March 26, 1992
LD-92-043

Docket No. 52-002

Subject: Structural and Geosciences Engineering

This letter transmits the single remaining outstanding RAI response (#230.1). Although responses have now been submitted for all 1463 RAIs, we will continue to work with NRC staff to resolve any comments and to supplement those responses which referenced future work (e.g., Shutdown Risk and PRA).

Figure 230.1-1 - Variation of Spectral Accelerations with Depth of Soil to Bedrock
(Free-field Ground Surface)

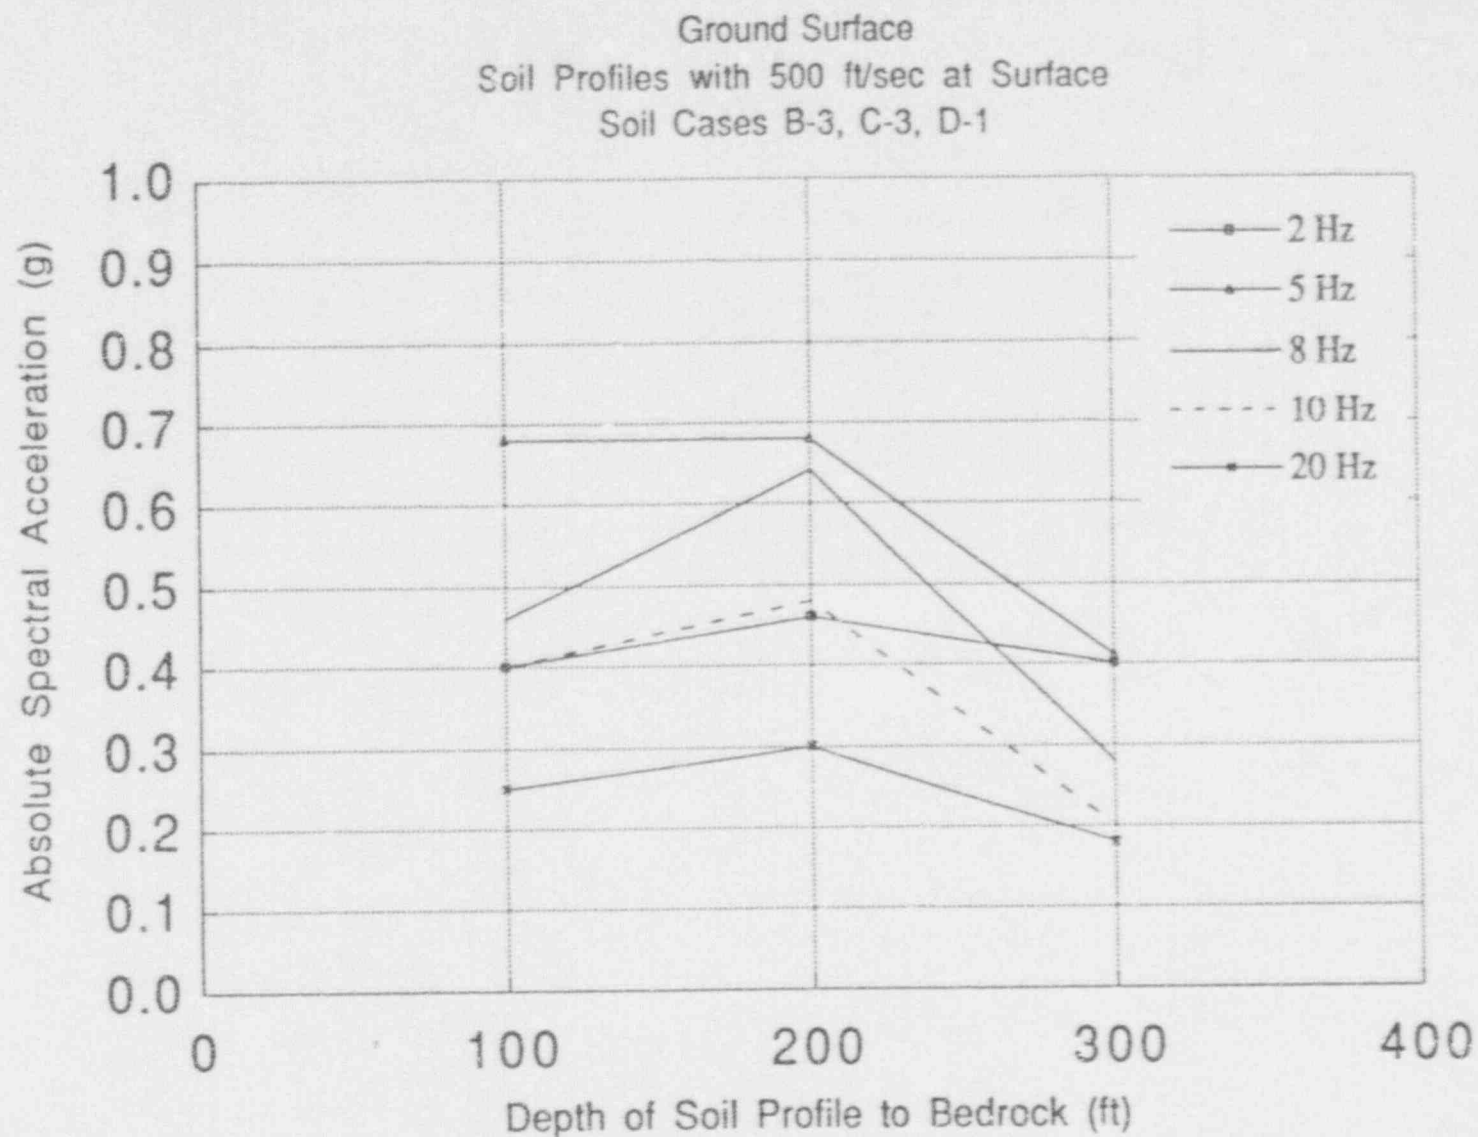
Section 2.5 - There are many nuclear power plants in the U.S. built on deep soil sites. Justify the argument that soil sites having a total depth to bedrock greater than 300 feet (Figure 2.5-1) are covered by the twelve soil cases analyzed as stated in Page 2.5-2.

Spectral accelerations at selected frequencies are plotted in Figures 230.1-1 and 230.1-2 as a function of soil depth to bedrock. Figure 230.1-1 corresponds to accelerations at the free-field ground surface and Figure 230.1-2 corresponds to spectral accelerations at the free-field foundation level. In both plots it is shown that spectral accelerations show significant decrease for the 300 ft. soil case, which is indicative of the trend that accelerations follow with increasing depth to bedrock. Therefore, deep soil sites are enveloped by the twelve soil cases considered in the soil analyses.

Fig. 3.7-2 Calculated Horizontal & Vertical Spectral Ordinates at the Foundation Level for Case A-1

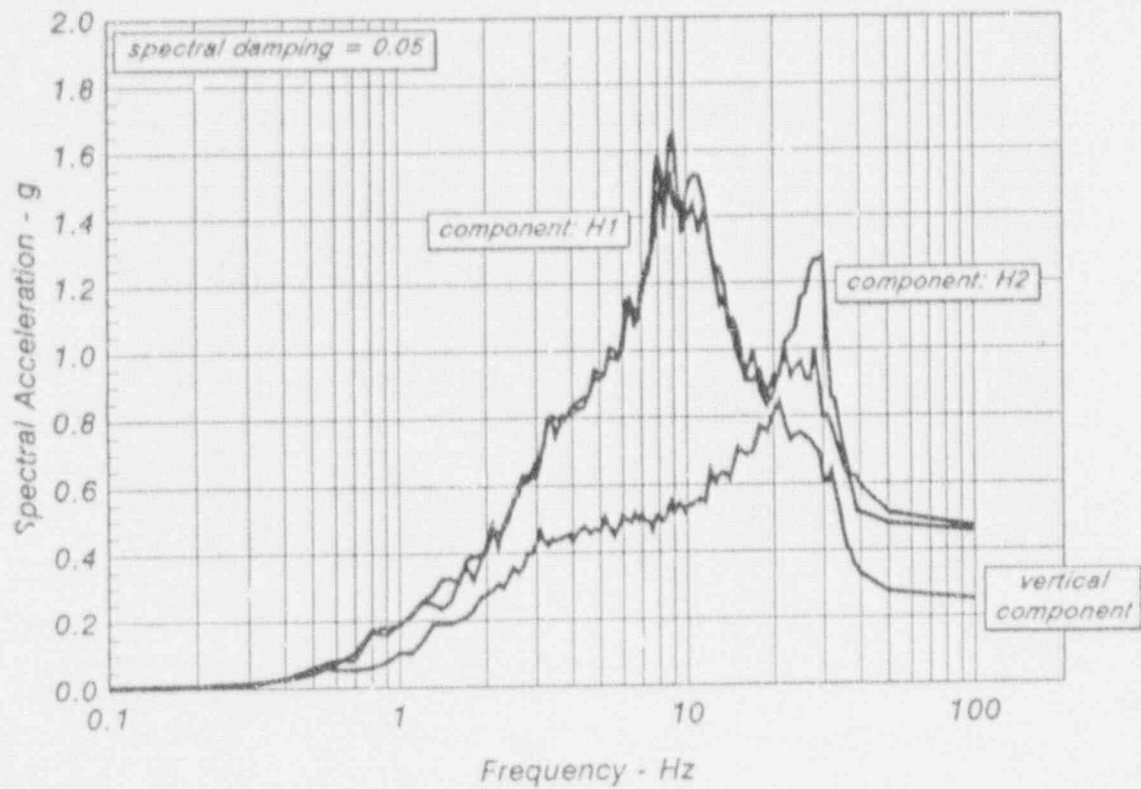
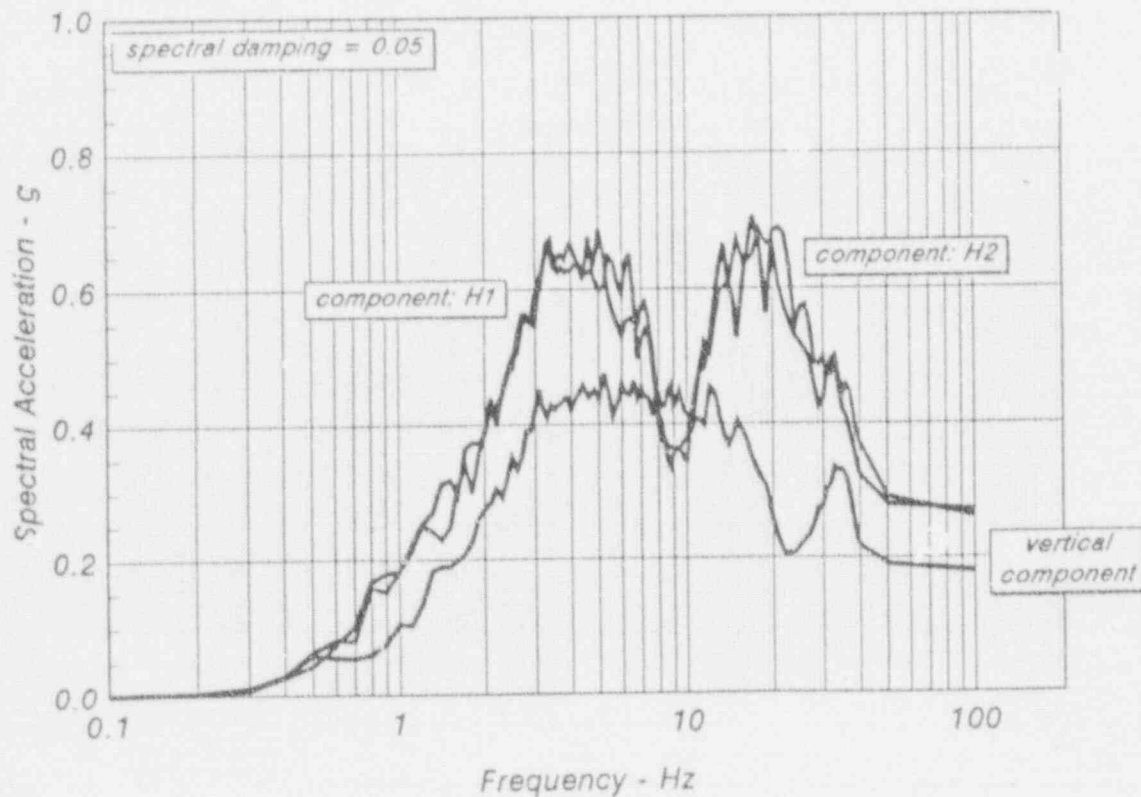
Section 3.7.1.1 - Explain why Figure 3.7-2 is practically identical to Figure 3.7-1. In Case A-1 (Figures 3.7-1 and 3.7-2), the bedrock is at the foundation level. Explain why, in the high frequency range, the horizontal and vertical spectral values converge to $0.5g$ and $0.3g$, respectively in both the cases.

The contents of Figs. 3.7-1 and 3.7-2 are identical because they both are for the calculated spectral ordinates at the ground surface for Case A-1. This situation has been corrected and the attached figures include the correct information at the ground surface and at the foundation level for Case A-1.

Figure 220.7-1 - Comparison of SRP PSD and Average PSD of Soil Case B3.5

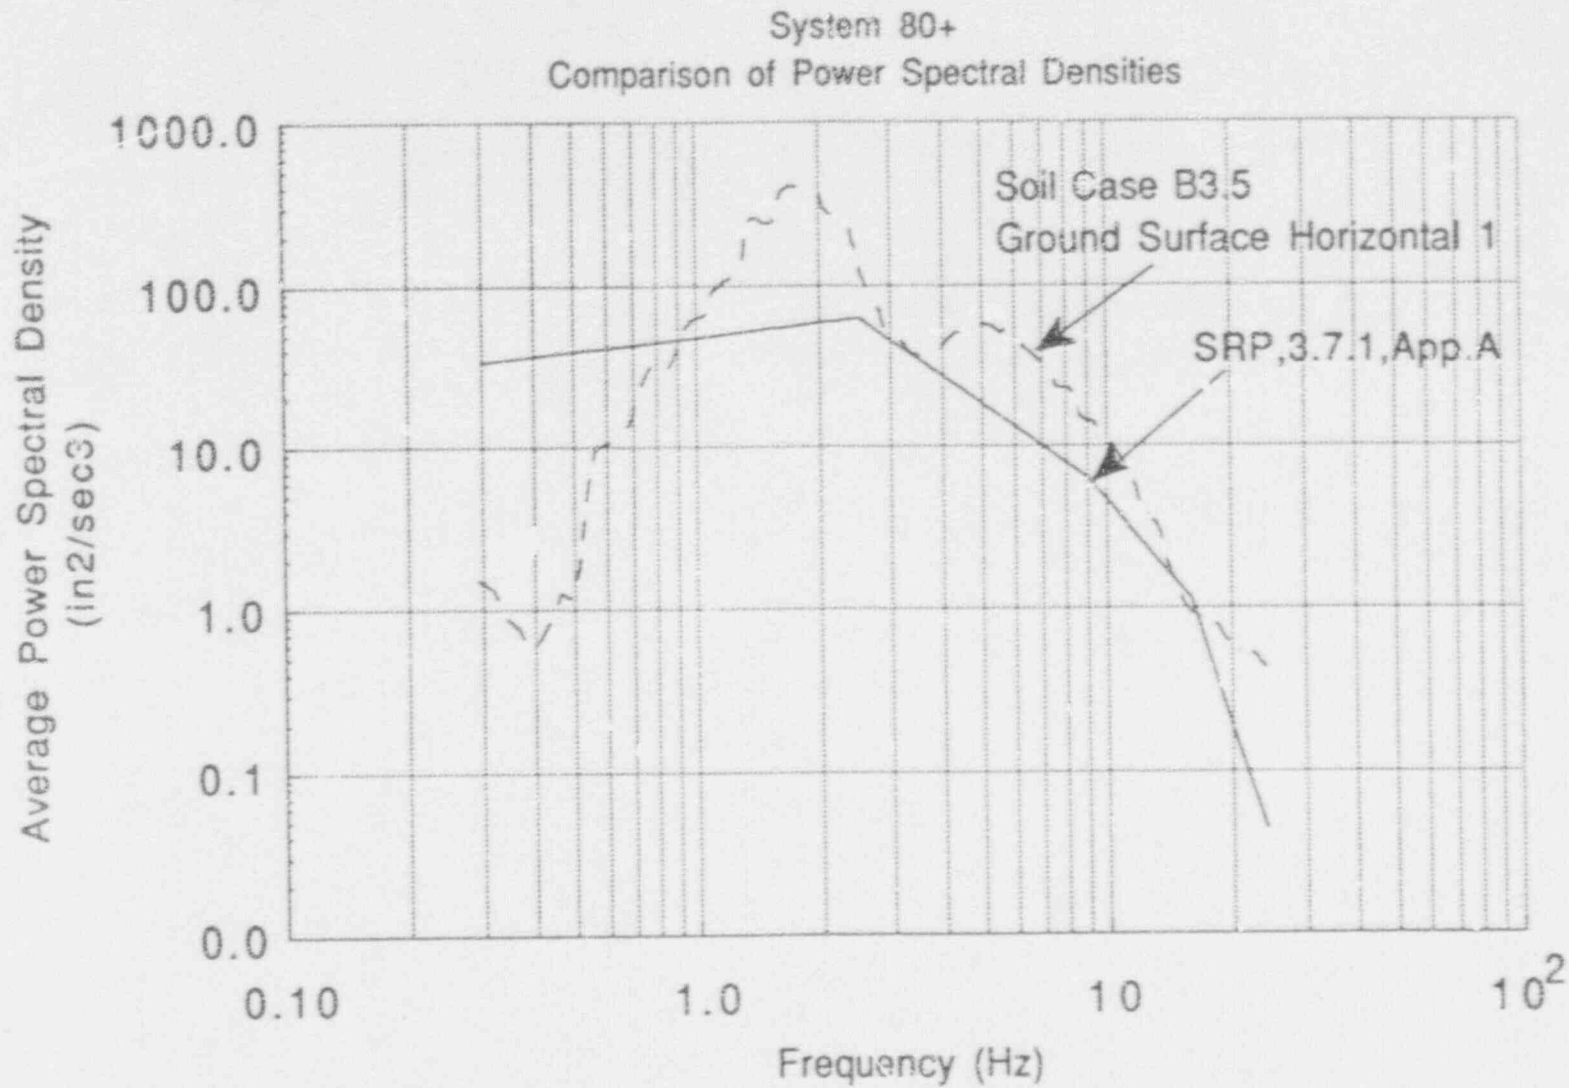
Section 3.7.1.1 - This section states that "For the time history method of analysis, three design time histories are generated that are consistent with the design rock outcrop spectra at the free field." Explain why these time histories instead of the time histories consistent with the spectra presented in Section 3.7.1.1 are used in the time history method of analysis. Also, compare the PSDs of the 3.7.1.1 spectra with the provisions of Appendix A of SRP 3.7.1.

the average PSD was computed over a frequency band width of $\pm 20\%$ centered on each frequency. The comparison of the B3.5 PSD with the SRP, 3.7.1, App. A target PSD is shown in Figure 220.7-1. The SPP PSD is normalized to a 0.35g peak acceleration, since 0.35g is the peak acceleration of the B3.5 soil case at the ground surface.

Figure 220.7-1 shows that the B3.5 PSD conservatively exceeds the SRP PSD at all frequencies above 0.9 Hz. The frequency range below 0.9 Hz has no structural significance. Also, there are softer soil profiles with surface motions that have more power in the frequency range below 0.9 Hz.
